SS 1033463 - WST 4700 Transmission Oil Cooler Lines Routing Improvements

Applicable Vehicles

WST 4700 w/Allison Transmissions

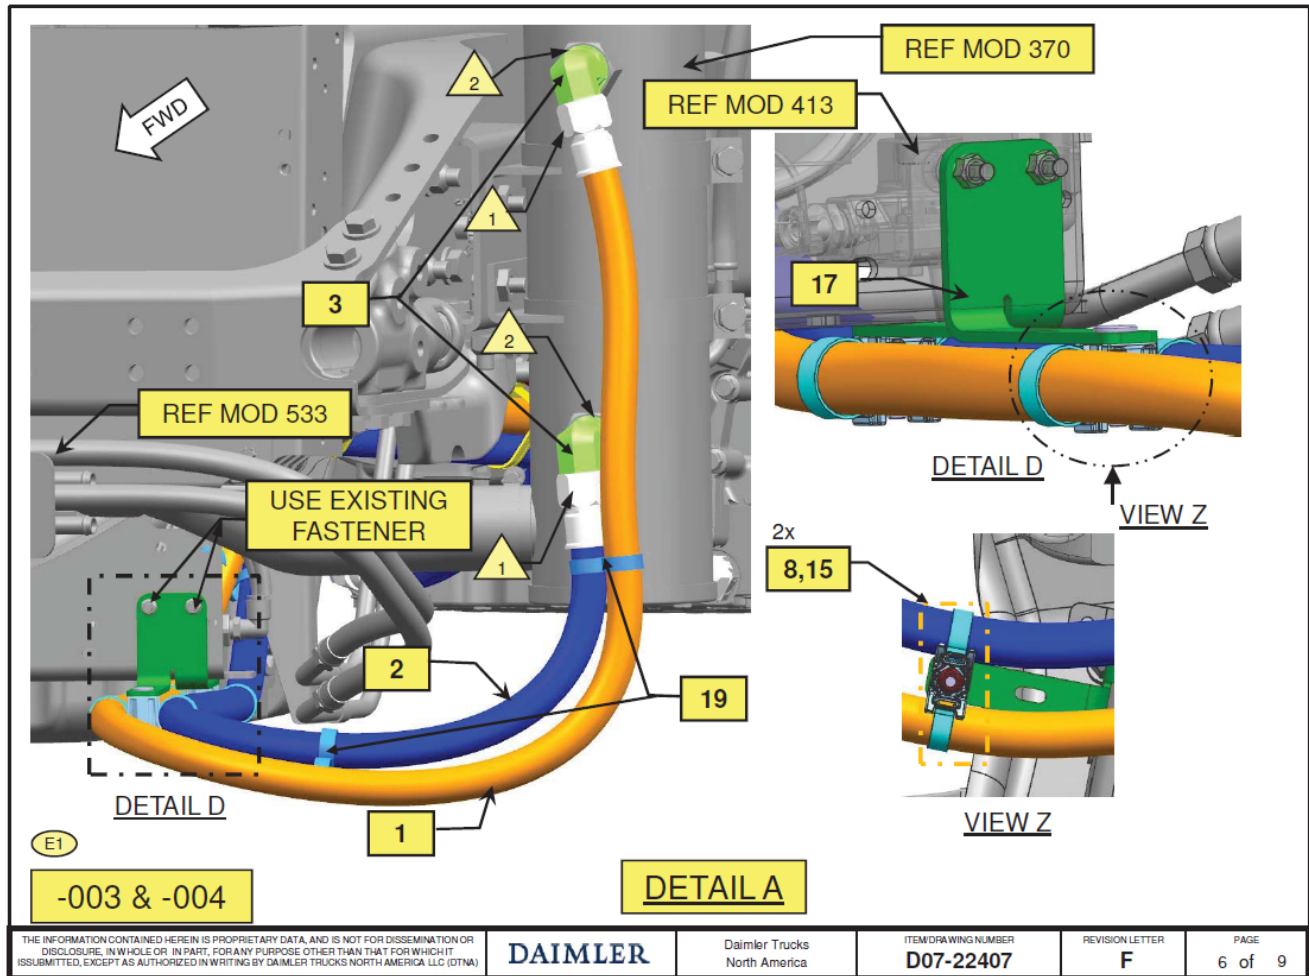
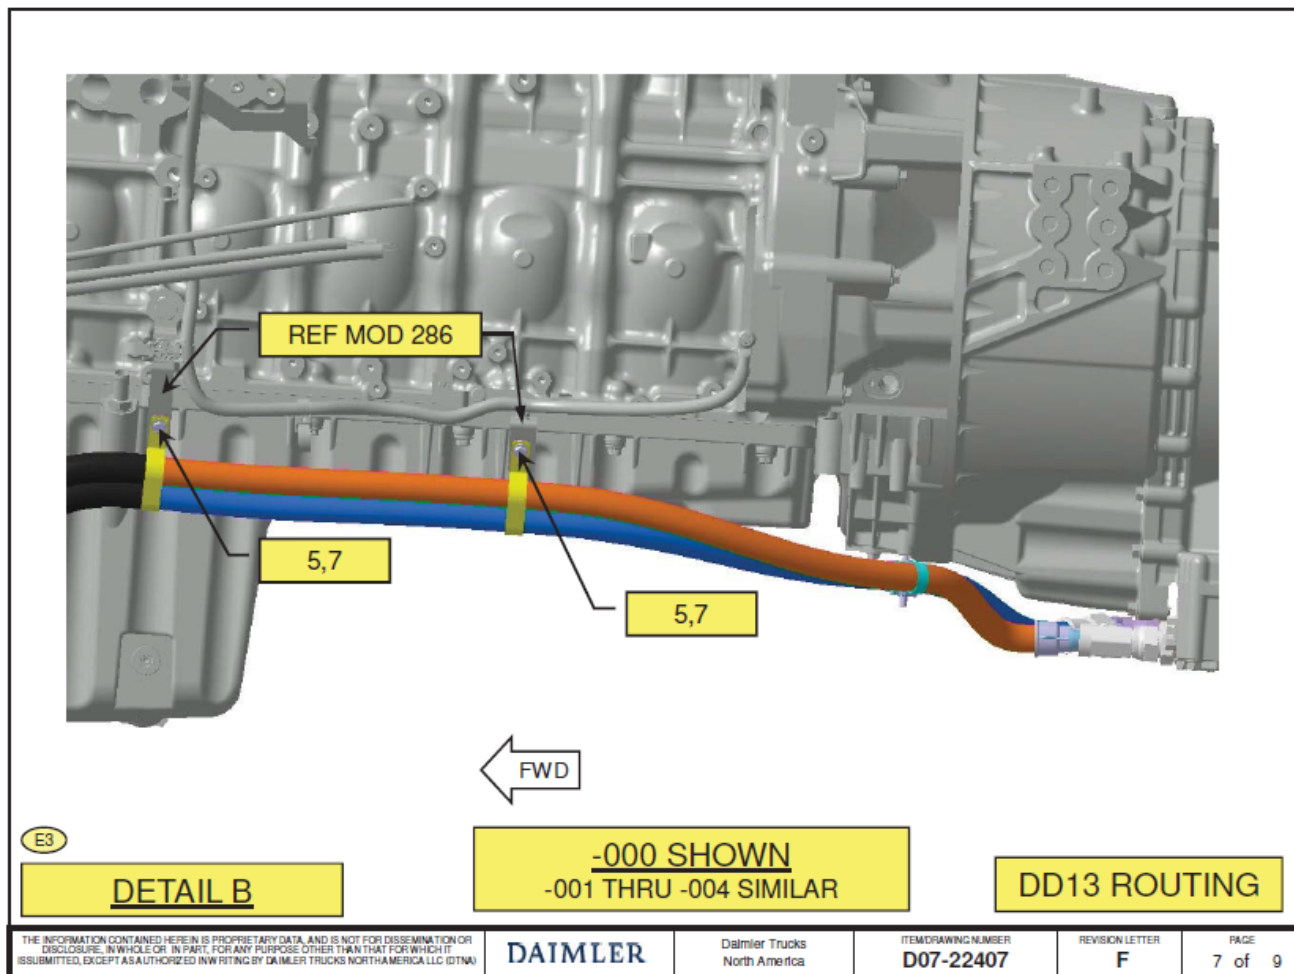
Transmission Cooler lines potentially damaged due to road debris.

Transmission cooler lines are routed below the oil pan where they may be exposed to potentially damaging road debris.

Transmission Cooler Lines routing has been revised to raise them higher in the truck eliminating the potential for damages due to road debris. New shorter Oil Cooler Lines are required besides new Clamps and a new bracket.

Follow new installation diagram D07-22407-003/004 to resolve issues:
